**Center for Advanced
Aviation System Development**

Nuevo Aeropuerto Internacional de la Ciudad de México Preliminary Airspace Redesign

Informal Working Notes on Departure Procedures

30 June 2016

Figure A-13. NAICM RNAV SID: Runway 2 Land North (NAICM_SID_WN_Land_North_R2)

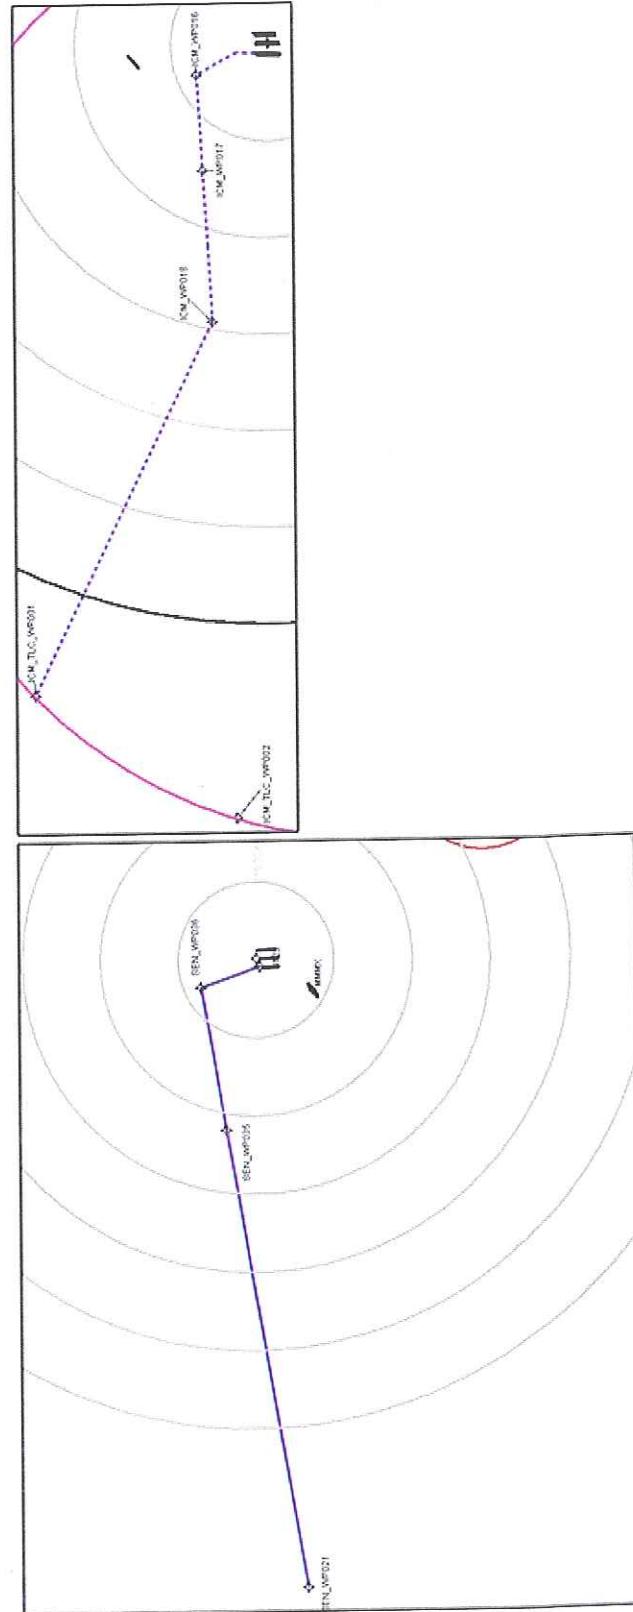
SENEAM and MITRE agreed to create two exit fixes on the western TMA boundary. Both fixes are located at a 50 NM range from the Toluca VOR (TLC). The graphic on the right displays the location of both fixes and their relative position to each other. The departure initially diverges by 30 degrees from runway heading. At waypoint ICM_WP017, the departures are deconflicted from the NAICM downwind traffic and can then climb unrestricted.

Figure A-14. NAICM RNAV SID: Runway 2 Land North (NAICM_SID_WN_Land_North_R2_A15)

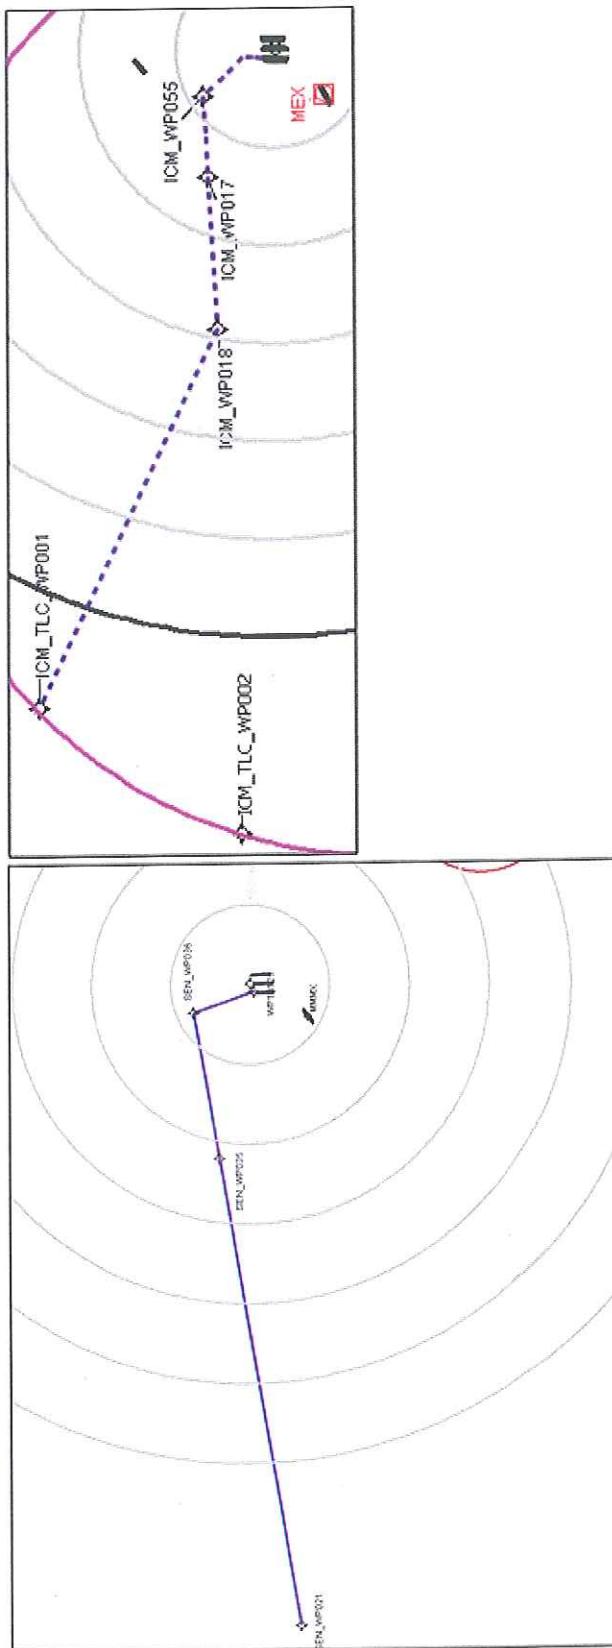
SENEAM and MITRE agreed to create two exit fixes on the western TMA boundary. Both fixes are located at a 50 NM range from the Toluca VOR (TLC). The graphic on the right displays the location of both fixes and their relative position to each other. The departure initially diverges by 45 degrees from runway heading. At waypoint ICM_WP017, the departures are deconflicted from the NAICM downwind traffic and can then climb unrestricted. This is an alternate design that is offset by 15 degrees from the original design, NAICM_SID_WN_Land_North_R2, shown in Figure A-13.

Figure A-15. NAICM RNAV SID: Runway 2 Land North (NAICM_SID_WN_Land_North_R2_A45)

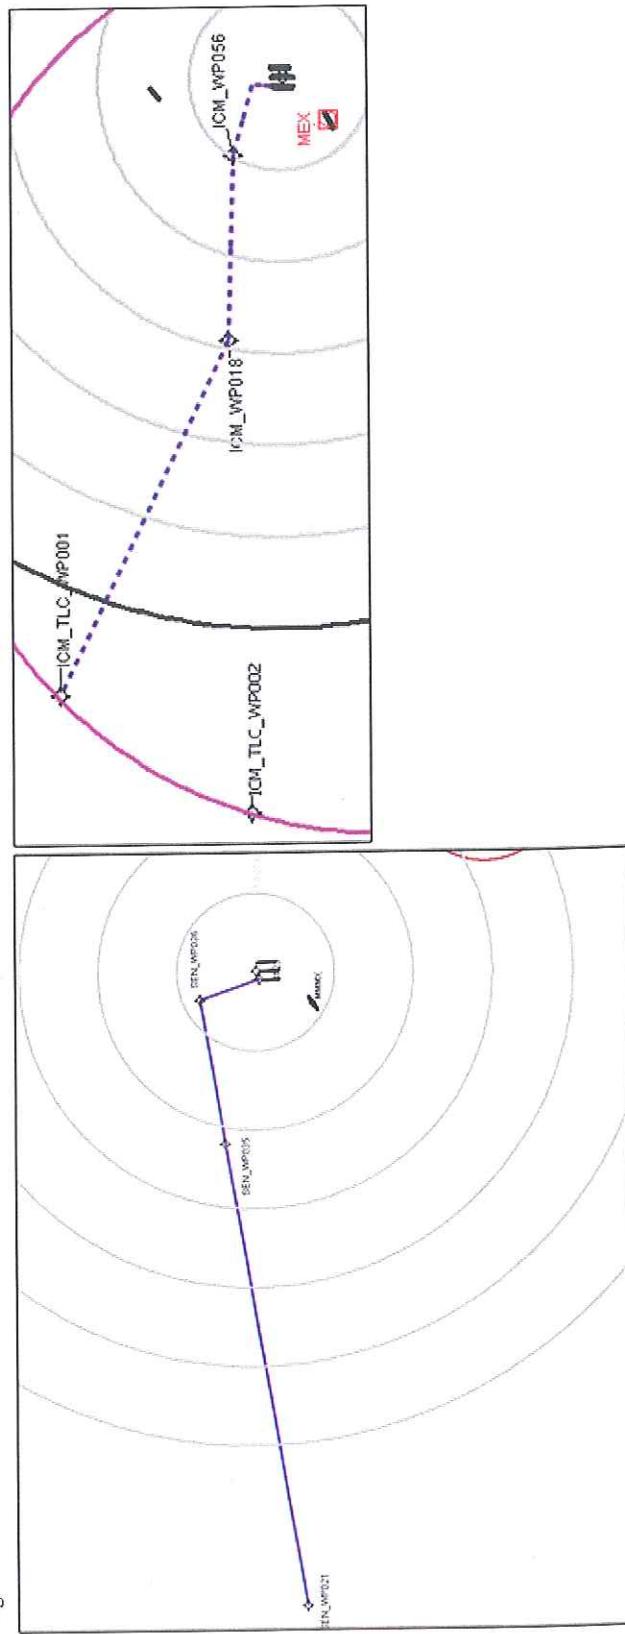
SENEAM and MITRE agreed to create two exit fixes on the western TMA boundary. Both fixes are located at a 50 NM range from the Tolula VOR (TLC). The graphic on the right displays the location of both fixes and their relative position to each other. The departure initially diverges by 75 degrees from runway heading. At waypoint ICM_WP018, the departures are deconflicted from the NAICM downwind traffic and can then climb unrestricted. This is an alternate design that is offset by 45 degrees from the original design, NAICM SID_WN_Land_North_R2, shown in Figure A-13.

Figure A-16. NAICM RNAV SID: Runway 2 Land North (NAICM_SID_NW_Land_North_R2)

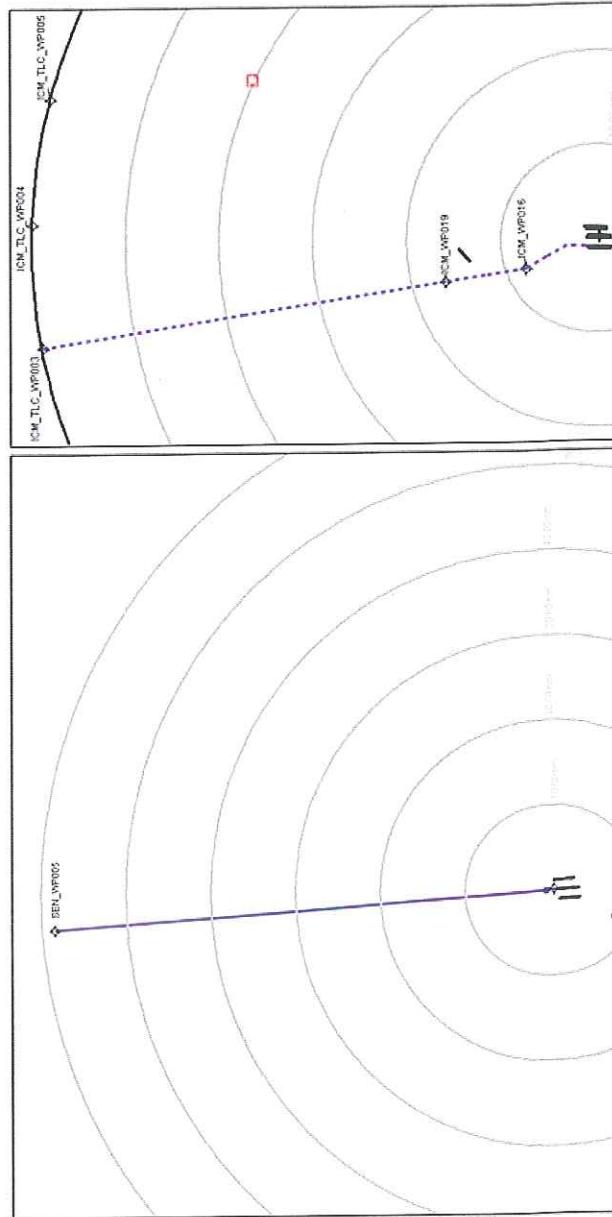
SENEAM and MITRE agreed to create three exit fixes on the northern TMA boundary at a 60 NM range from the NAICM reference point provided by SENEAM. The graphic on the right displays the location of all three fixes and their relative position to each other. The departure initially diverges by 30 degrees from runway heading.

Figure A-17. NAICM RNAV SID: Runway 2 Land North (NAICM_SID_N_Land_North_R2)

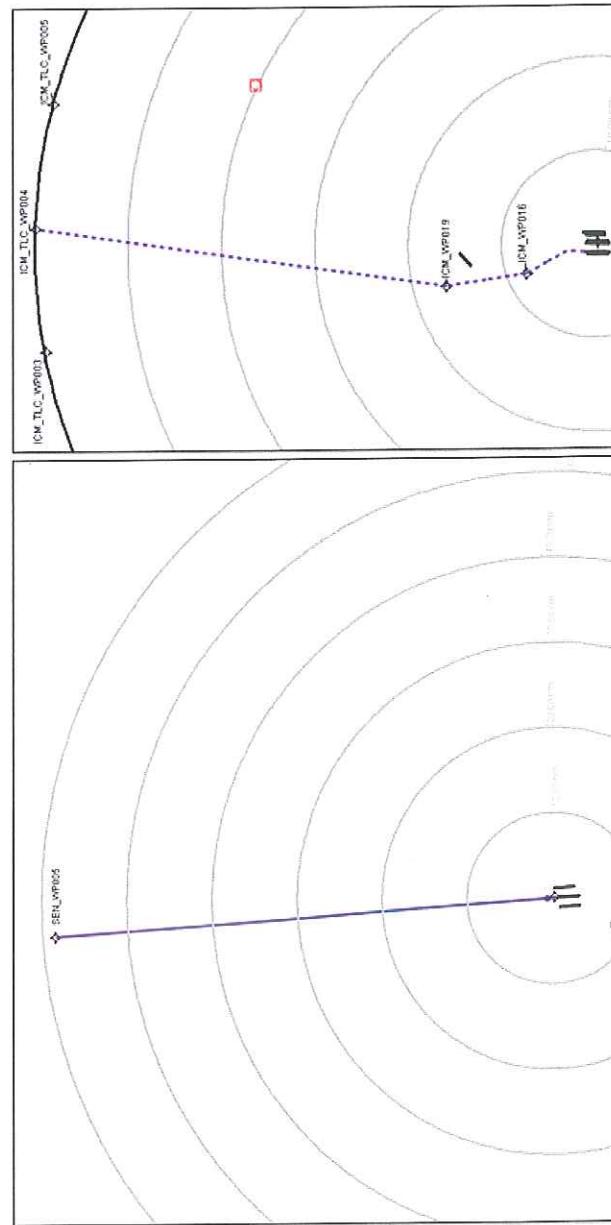
SENEAM and MITRE agreed to create three exit fixes on the northern TMA boundary at a 60 NM range from the NAICM reference point provided by SENEAM. The graphic on the right displays the location of all three fixes and their relative position to each other. The departure initially diverges by 30 degrees from runway heading.

Figure A-18. NAICM RNAV SID: Runway 2 Land North (NAICM_SID_NE_Land_North_R2)

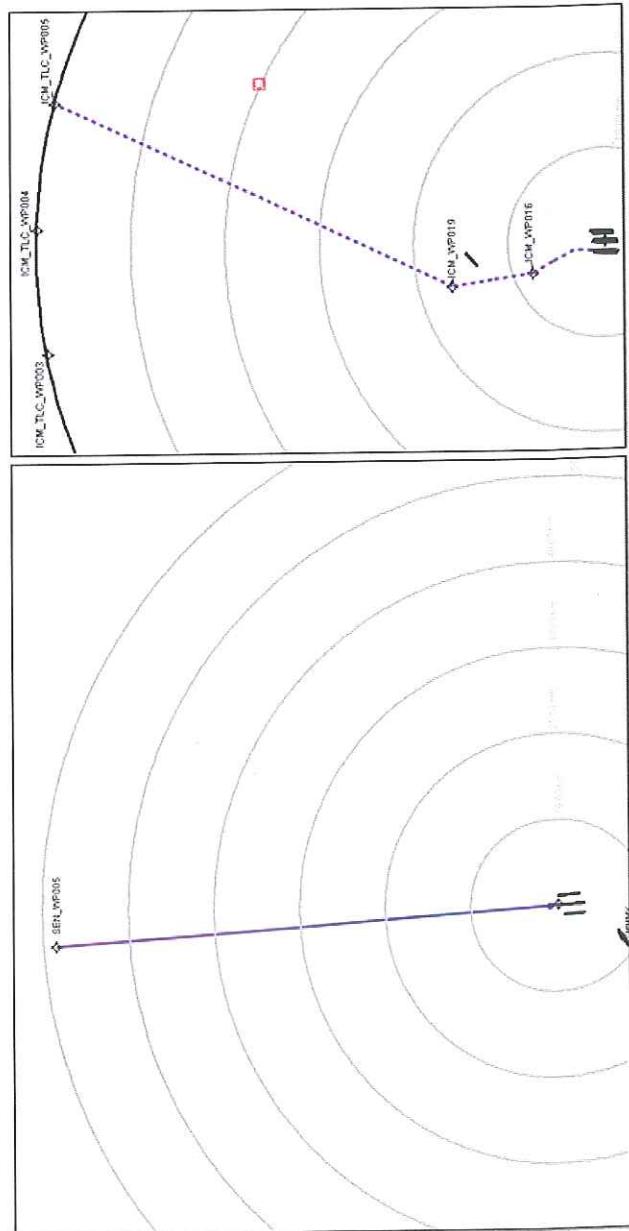
SENEAM and MITRE agreed to create three exit fixes on the northern TMA boundary at a 60 NM range from the NAICM reference point provided by SENEAM. The graphic on the right displays the location of all three fixes and their relative position to each other. The departure initially diverges by 30 degrees from runway heading.

Figure A-19. NAICM RVAV SID: Runway 3 Land North (NAICM_SID_EN_Land_North_R3)

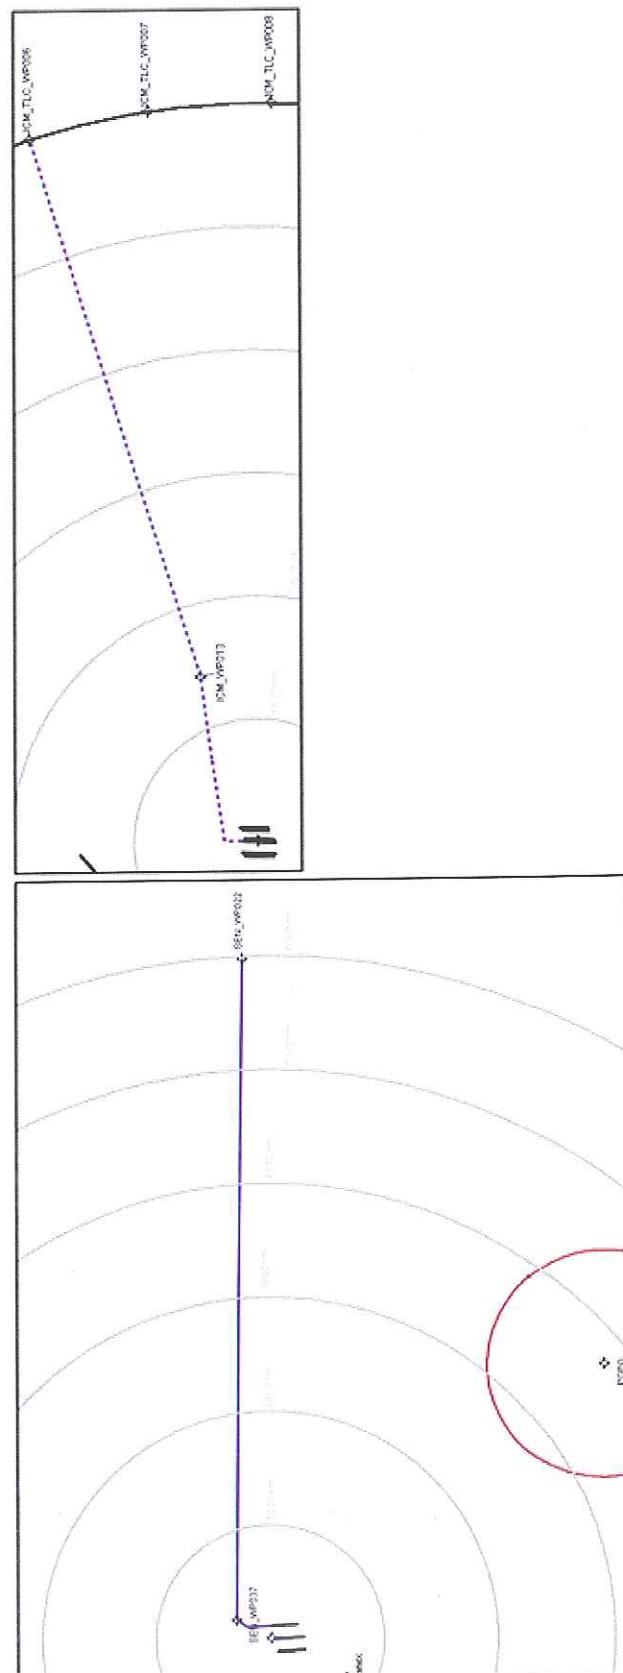
SENEAM and MITRE agreed to create three exit fixes on the eastern TMA boundary. The graphic on the right displays the location of all three fixes and their relative position to each other. The waypoint ICM_WP013 was added to restrict departures below the NAICM arrivals on downwind.

Figure A-20. NAICM RNAV SID: Runway 3 Land North (NAICM_SID_E_Land_North_R3)

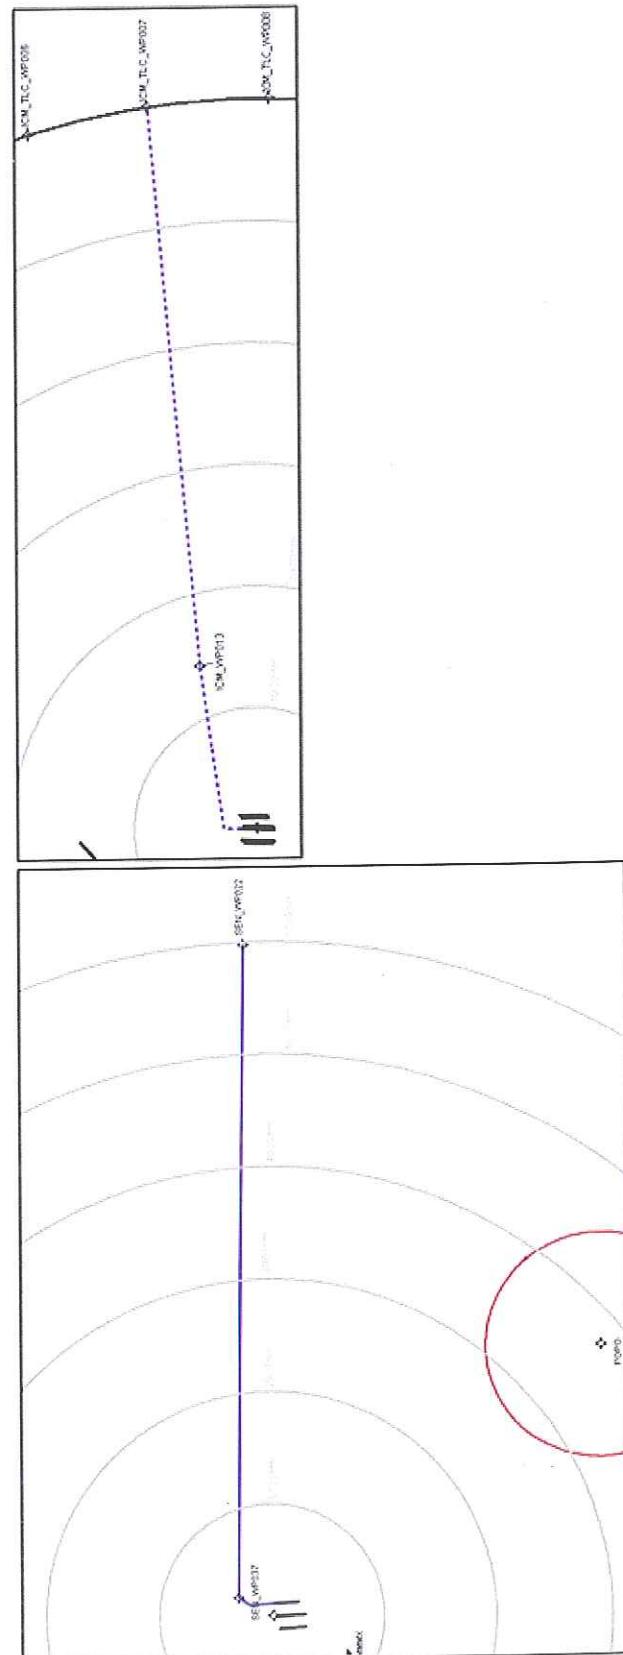
SENEAM and MITRE agreed to create three exit fixes on the eastern TMA boundary. The graphic on the right displays the location of all three fixes and their relative position to each other. The waypoint ICM_WP013 was added to restrict departures below the NAICM arrivals on downwind.

Figure A-21. NAICM RNAV SID: Runway 3 Land North (NAICM_SID_ES_Land_North_R3)

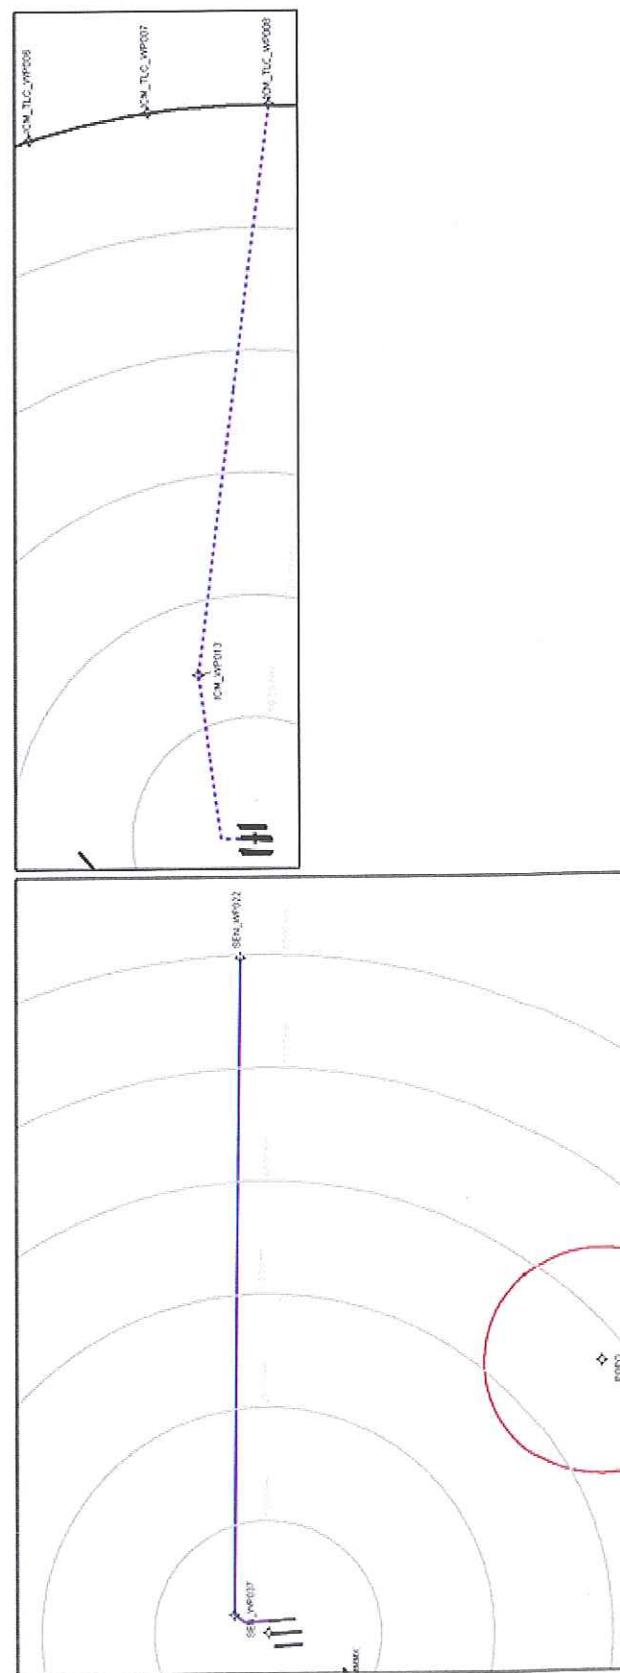
SENEAM and MITRE agreed to create three exit fixes on the eastern TMA boundary. The graphic on the right displays the location of all three fixes and their relative position to each other. The waypoint ICM_WP013 was added to restrict departures below the NAICM arrivals on downwind.

Figure A-22. NAICM RNAV SID: Runway 3 Land North (NAICM_SID_SE_Land_North_R3)

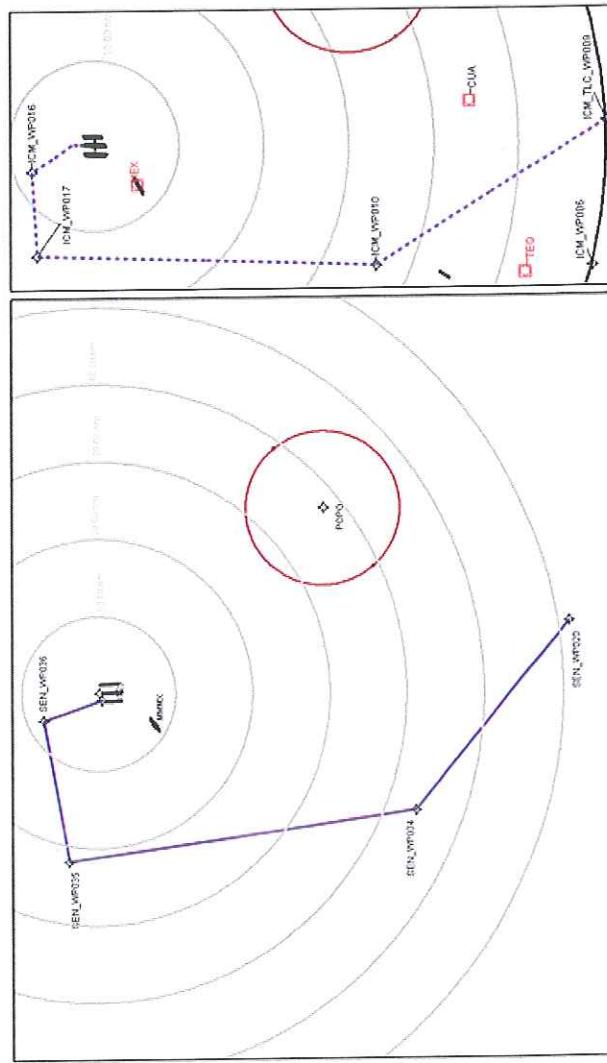
SENEAM and MITRE agreed to create two exit fixes on the southern TMA boundary at a 60 NM range from the NAICM reference point provided by SENEAM. The graphic on the right displays the location of both fixes and their relative position to each other. The departure initially diverges 30 degrees from runway heading. At waypoint ICM_WP017, the departures are deconflicted from the NAICM downwind traffic and can then climb unrestricted. At waypoint ICM_WP010, the aircraft will be above the NAICM arrival traffic from the southwest.

Figure A-24. NAICM RNAV SID: Runway 3 Land North (NAICM_SID_SW_Land_North_R3)

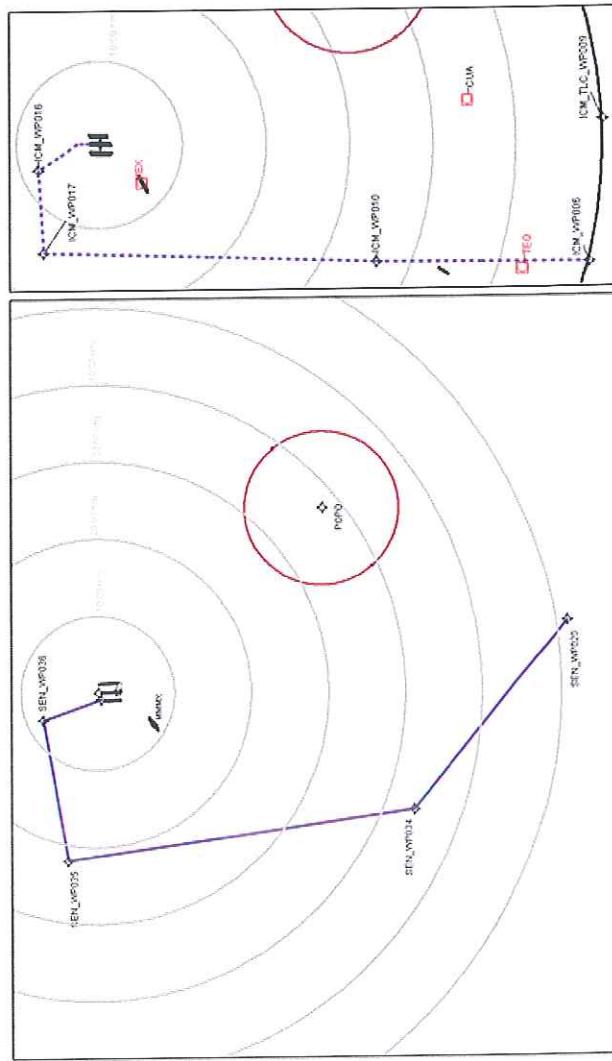
SENEAM and MITRE agreed to create two exit fixes on the southern TMA boundary at a 60 NM range from the NAICM reference point provided by SENEAM. The graphic on the right displays the location of both fixes and their relative position to each other. The departure initially diverges 30 degrees from runway heading. At waypoint ICM_WP017, the departures are deconflicted from the NAICM downwind traffic and can then climb unrestricted. At waypoint ICM_WP010, the aircraft will be above the NAICM arrival traffic from the southwest.
